# Application to Change or Waive Requirements of the Broward County Land Development Code

Plat/Site Plan Name\_Miramar Central Plaza Plat

Re: Miramar Central Plaza Plat – Delegation Request Narrative

Re: Miramar Central Plaza Plat

# **EXISTING NON-VEHICULAR ACCESS LINE**

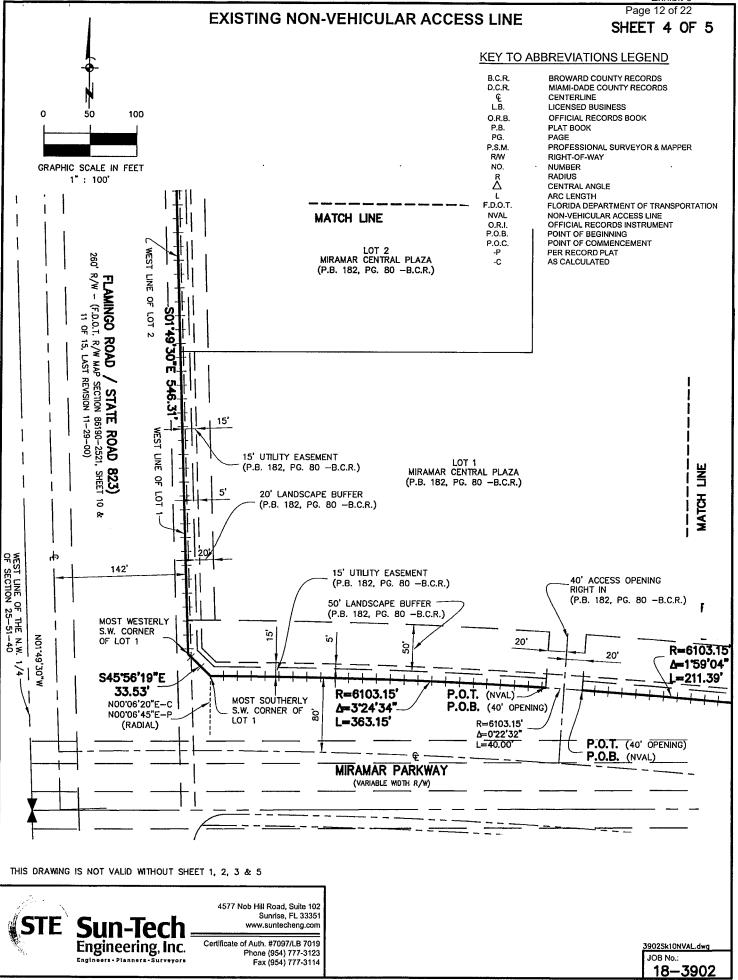
Based on comments provided by the City Development Review Committee ("DRC"), the Applicant is proposing to modify the 100' full access opening on Miramar Parkway depicted on the sketch and legal description attached as **Exhibit A** to restrict left out movements at this opening. It has been determined that this access would function with improved safety if movements are restricted to right in, left in, and right out versus a full access median opening as shown on the sketch and legal description attached as **Exhibit B**.

The Applicant is proposing to eliminate the 80' access opening currently permitting right in, right out movements along Flamingo Road with centerline approximately 115 feet south of the north plat limits. The Applicant proposes to eliminate the 80' access opening and remove the condition for a northbound right in turn lane that would conflict with the proposed full access opening on Flamingo Road.

### AMENDED NON-VEHICULAR ACCESS LINE

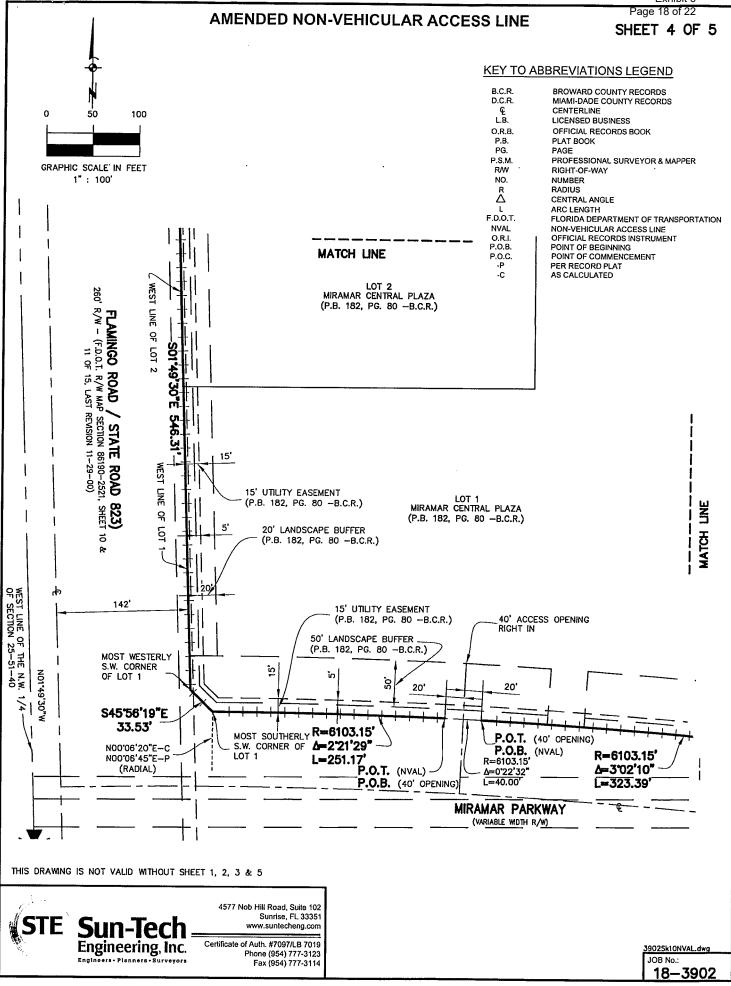
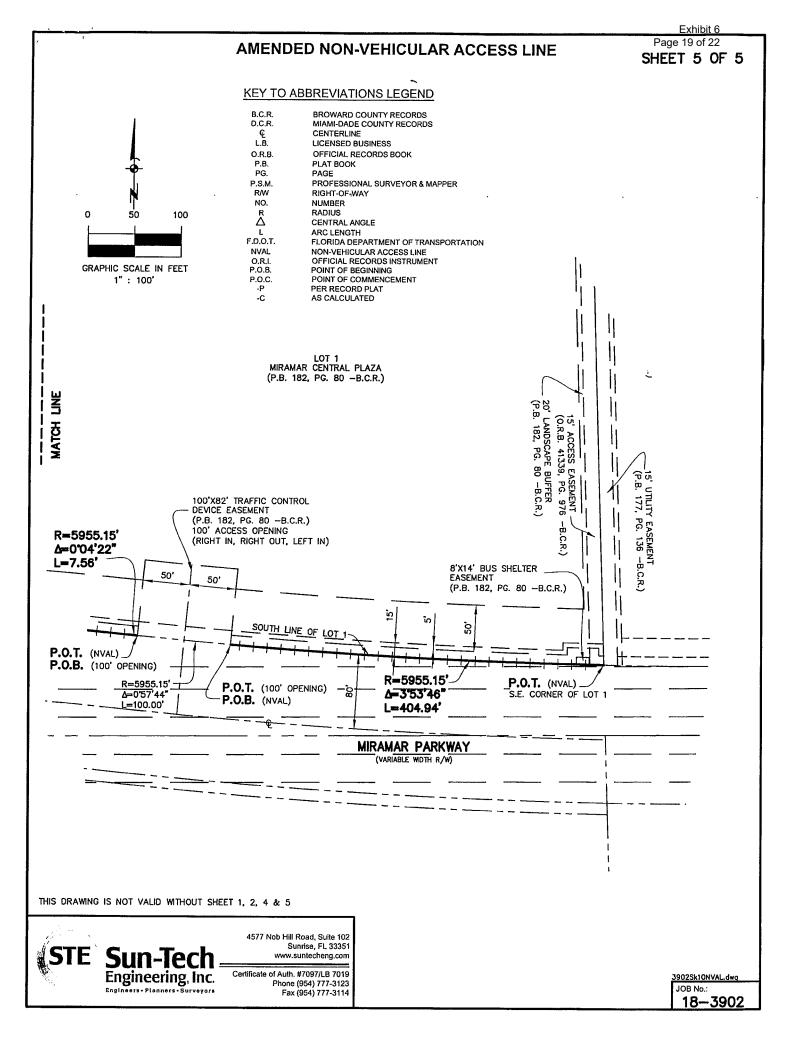
- Modify 100' full access opening on Miramar Parkway to restrict left out movements
- Eliminate 80' right in, right out access opening on Flamingo Road and related right-of-way dedication and driveway conditions
- Relocate 40' right in only access opening on Miramar Parkway with centerline to be located approximately 855 feet west of the east plat limits.

The Applicant is also proposing to shift the 40' access opening on Miramar Parkway by approximately 115 feet to the west to increase the amount of internal stacking available thereby reducing the potential for traffic impacts on Miramar Parkway. This access will allow direct entrance into the commercial portion of the development from vehicles moving westbound on Miramar Parkway.

- Eliminate 80' right in, right out access opening on Flamingo Road
- Modify 100' full access opening on Miramar Parkway to restrict left out movements
- Provide an 8'x14' bus shelter easement along Miramar Parkway east of the 40' right in access opening
- "Slightly modify the position of the 40' access opening right in on Miramar Parkway from the existing NVAL depicted on sheet 4 of 7 of the Plat attached as Exhibit A to the proposed position as depicted on the site plan attached as Exhibit B".
